Project T10/1760-D

Revision 14
28 January 2008

Information technology - Serial Attached SCSI - 2 (SAS-2)

Summary of Comments on Serial Attached SCSI - 2 (SAS-2) Standard

Figure 40 — Reset terminology

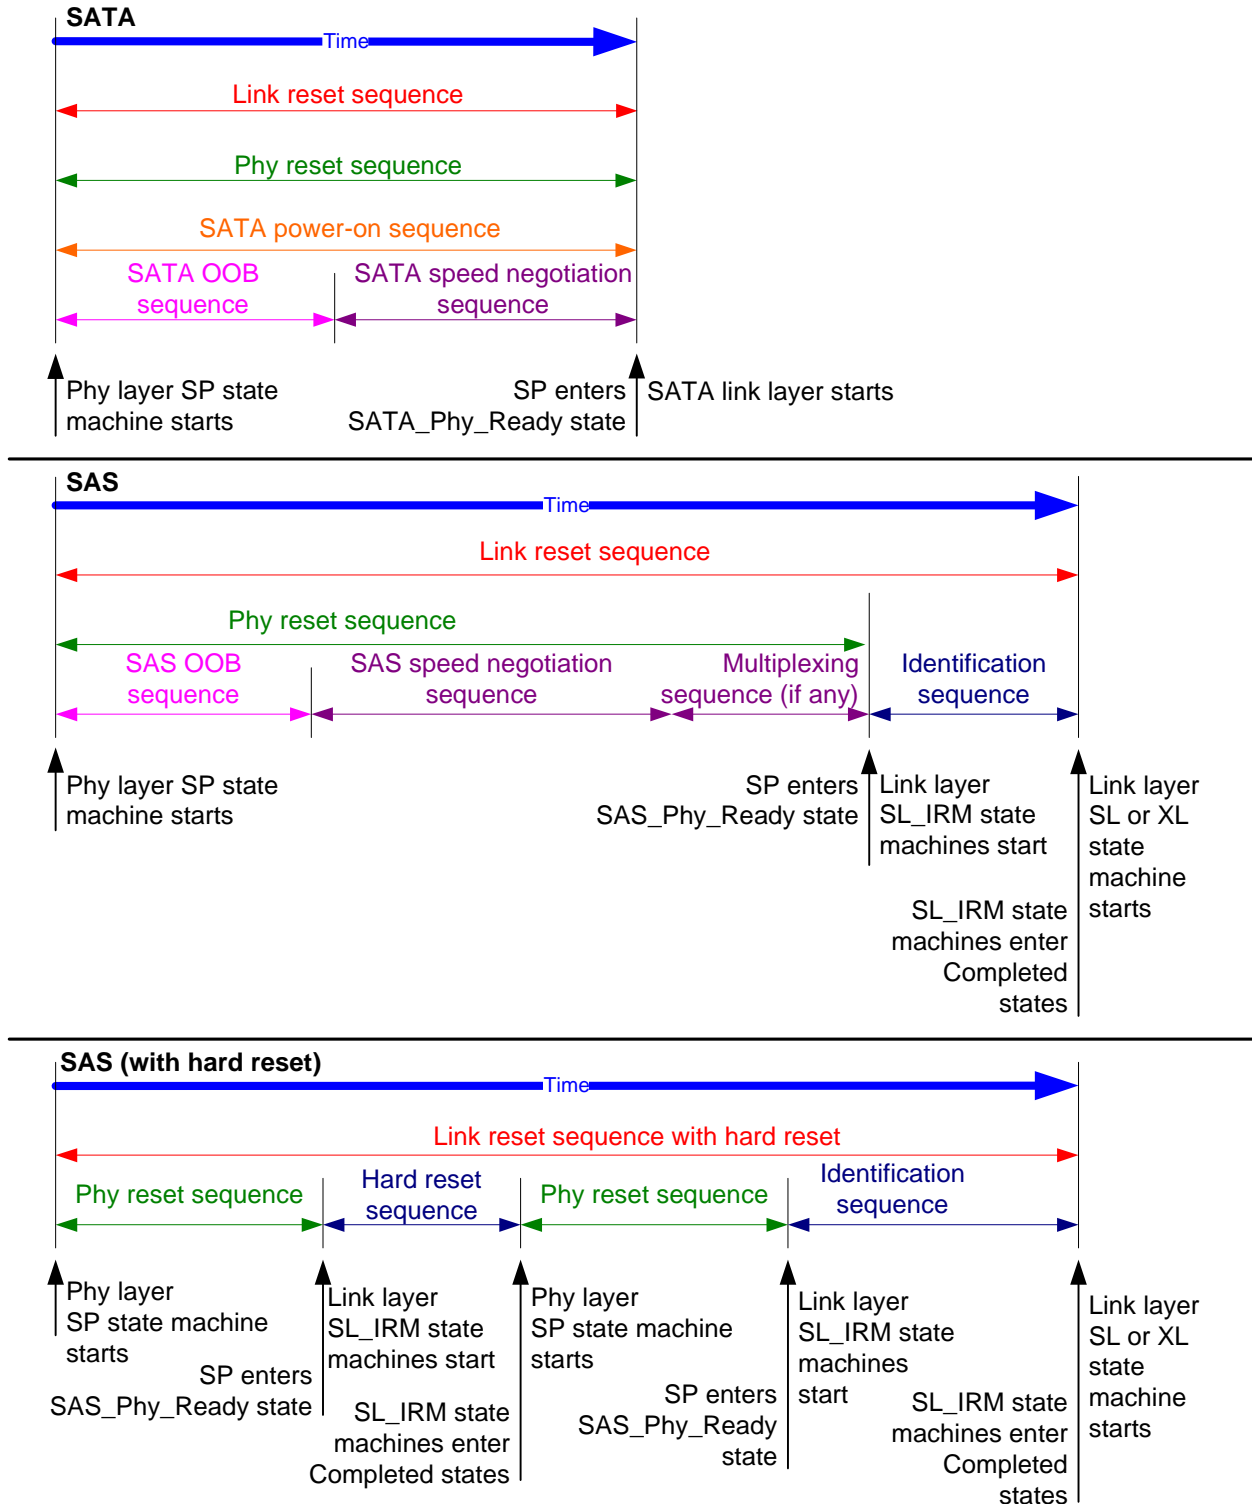
Figure 40 illustrates the reset terminology used in this standard:

T ACCEPT - DONE (7/15 global change "illustrates" to "shows" in cases like this.)

Figure 50 — Expander route index order example

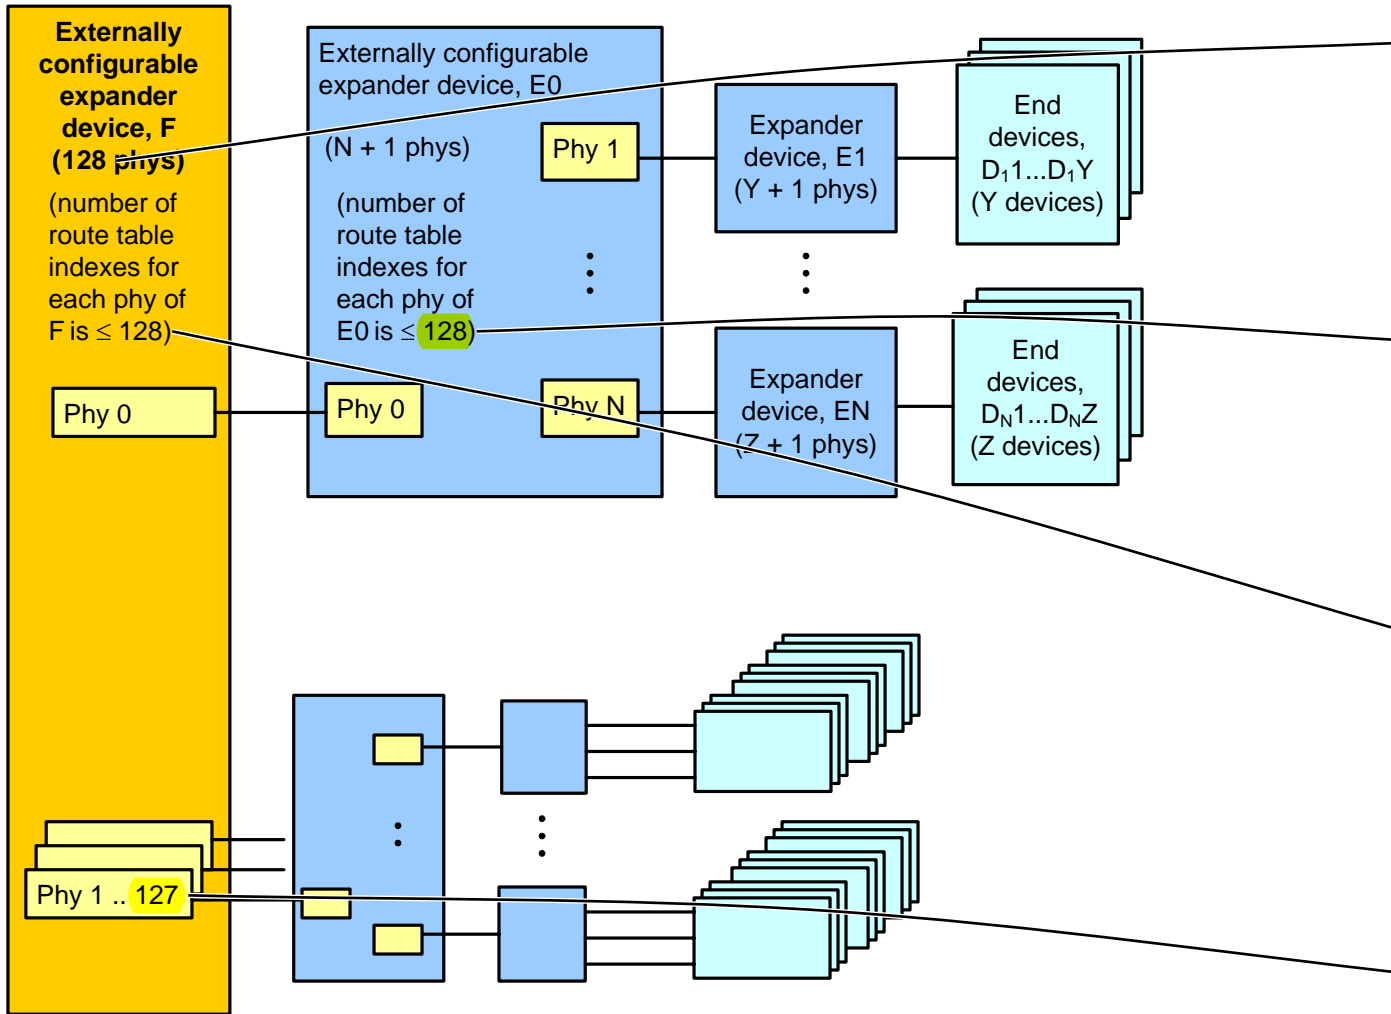
in figure 50, not table 50: 128 to 255, deleted two unnecessary sentences
